## Design-Covers for HL053M(P)-series

### Change of thickness from 8mm to 6mm

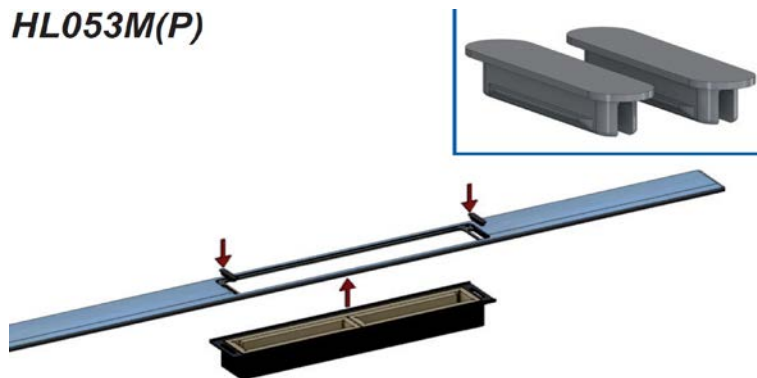
In the future all design covers of HL053M(P)-series will be delivered with thickness 6mm. Advantage: it is possible, to use flatter tiles. These changes have no influence on design, function or stability. All „standard“-covers (HL053S-series) remain unchanged. This switch will be performed fluently.

- 6mm Thickness without swallow-tail (old: 8mm)
- Cut-out for the middle sector: 266mm x 41,5mm (old: 257,5mm x 38,5mm)

- Size 286mm x 44mm x 5mm (old: 262mm x 43mm x 8mm)
- Spare part HL053M(P)/1.EN

- Fixing with a clip from the top (old: fixing from below) - s. picture above
- Tile height 10 – 32mm (old: 12 - 32mm)
